SUBJECT: ISSUANCE OF AMENDMENT NO. 120 TO FACILITY OPERATING LICENSE
NO. DPR-28 - VERMONT YANKEE NUCLEAR POWER STATION (TAC NO.75499)

AMENDMENT NO. 120 TO DPR-28 VERMONT YANKEE NUCLEAR POWER STATION DATED APR 17 1990

SAFETY EVALUATION BY THE OFFICE OF NUCLEAR REACTOR REGULATION
SUPPORTING AMENDMENT NO. 120 TO FACILITY OPERATING LICENSE NO. DPR-28

Figure 3.6.1 Reactor Vessel Pressure-Temperature Limitations

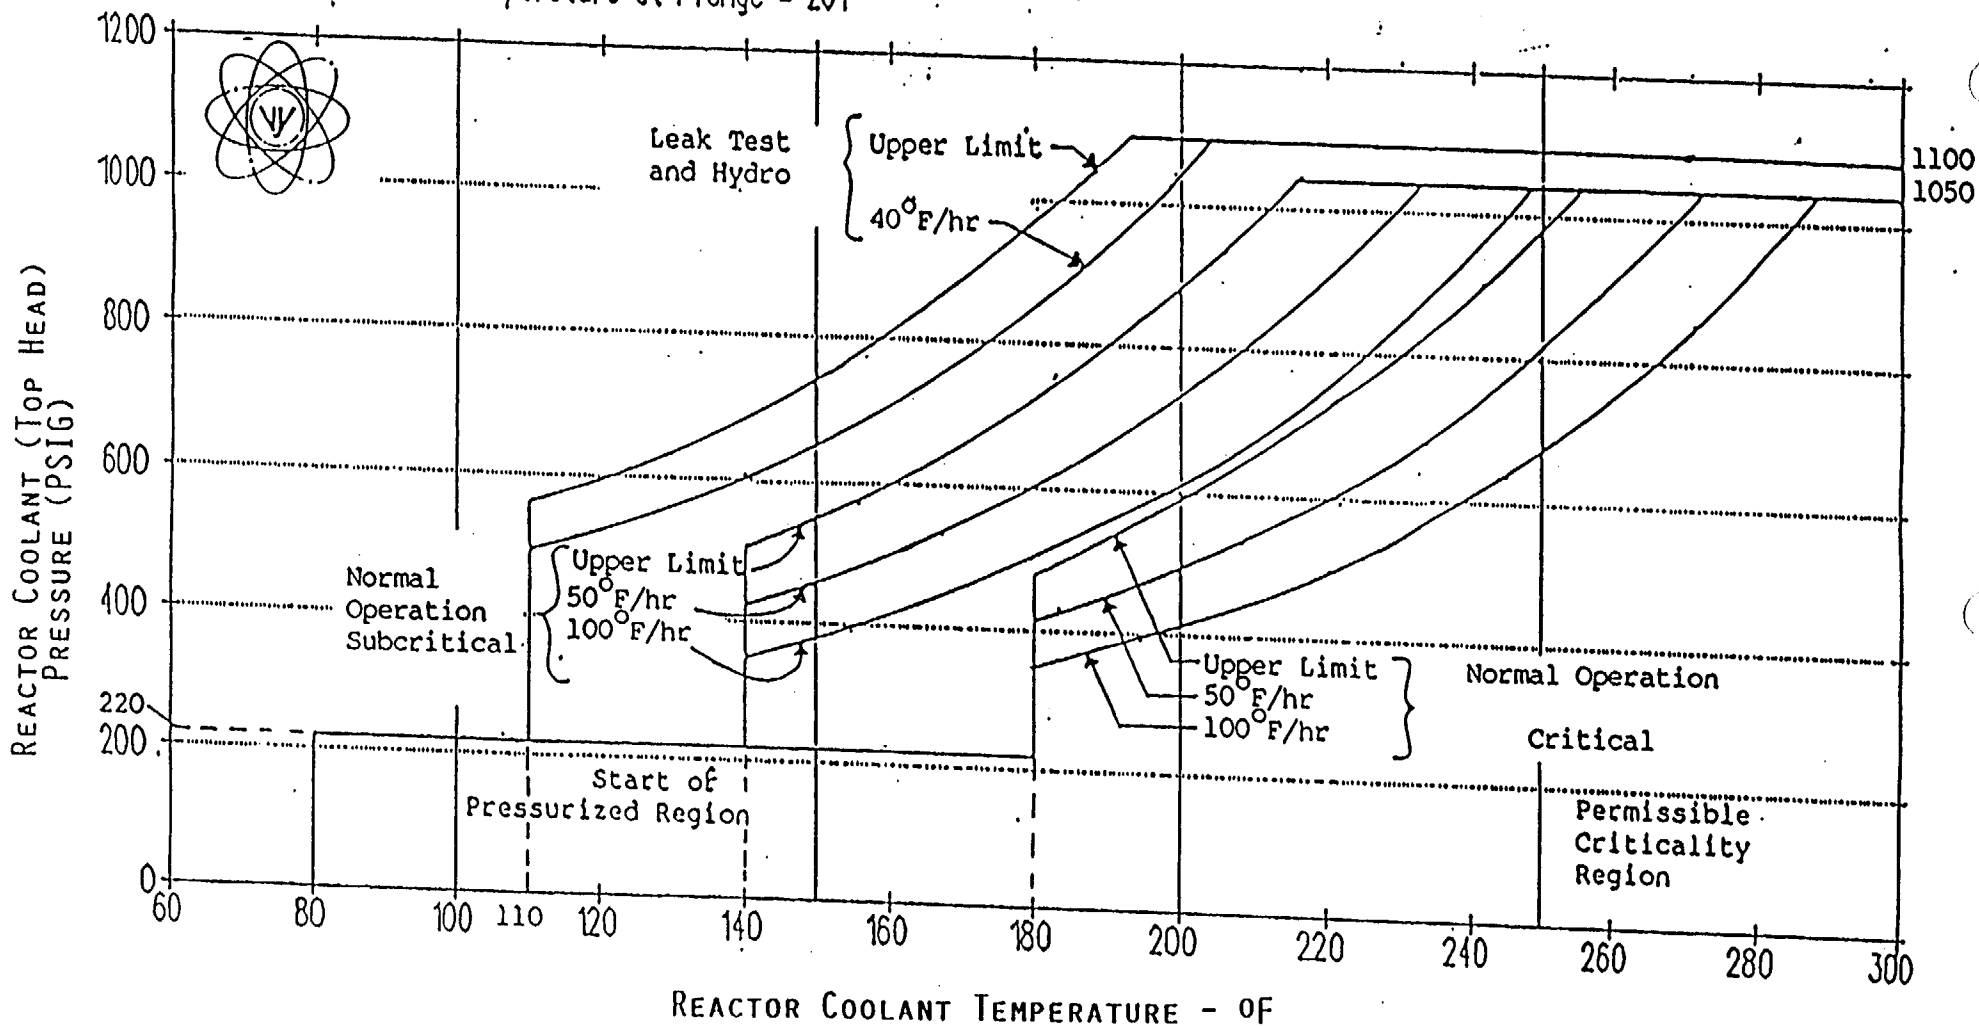
This amendment revises the Pressure-Temperature limit curves in Technical Specification (TS) Figure 3.6.1.

By letter dated November 10, 1989, the Vermont Yankee Nuclear Power Corporation (the licensee) requested an amendment to Facility Operating License No. DPR-28 for the Vermont Yankee Nuclear Power Station. The proposed amendment would revise the Pressure-Temperature limit curves in Technical Specification (TS) Figure 3.6.1.

This proposed TS change reflects the shift in transition temperature for the reactor vessel materials for operation through a cumulative energy output of 4.46×10^8 MWh(t). The change is necessary because the existing curves are limited to a cumulative energy output of 1.79×10^8 MWh(t) which is expected to be reached by May 1990.

Valid Thru 4.46E8 MWH(t) [32 EFPY]

Adjusted Reference Temperature at 1/4T = 89°F
Adjusted Reference Temperature at 3/4T = 73°F
Adjusted Reference Temperature at Flange = 20°F

For the limiting beltline material, plate I-14, the staff calculated the ART to be 63.1° F at 1/4T (T = reactor vessel beltline thickness) and 55.5° F for 3/4T at 32 EFPY. The staff used a neutron fluence of $1.6E17$ n/cm² at 1/4T and $9E16$ n/cm² at 3/4T. The ART was determined using Section 1 of RG 1.99, Rev. 2, as only one surveillance capsule has been removed from Vermont Yankee.

The licensee used a more conservative safety factor than the one in RG 1.99, Rev. 2, to calculate an ART of 89° F EFPY at 1/4T and 73° F at 3/4T at 32 EFPY

for a plate material in the beltline. The staff believes that an ART of 63.1° F is sufficient to protect the reactor vessel from embrittlement. Substituting the ART of 63.1° F into the equations in SRP 5.3.2, the staff verified that the proposed P/T limits for heatup, cooldown, and hydrotest meet the belt material requirement in Appendix G of 10 CFR Part 50.

In addition to beltline materials, Appendix G of 10 CFR Part 50 also imposes P/T limits based on the reference temperature for the reactor vessel closure flange materials. Paragraph IV.A.2 of Appendix G states that when the pressure exceeds 20% of the preservice system hydrostatic test pressure, the temperature of the closure flange regions highly stressed by the bolt preload must exceed the reference temperature of the material in those regions by at least 120° F for normal operation and by 90° F for hydrostatic pressure tests and leak tests. Paragraph IV.A.3 of Appendix G states "an exception may be made for boiling water reactor vessels when water level is within the normal range for power operation and the pressure is less than 20 percent of the pre-service system hydrostatic test pressure. In this case the minimum permissible temperature is 60° F (33° C) above the reference temperature of the closure flange regions that are highly stressed by the bolt preload." Based on the flange reference temperature of 20° F, the staff has determined that the proposed P/T limits satisfy paragraph IV.A.2 of Appendix G.
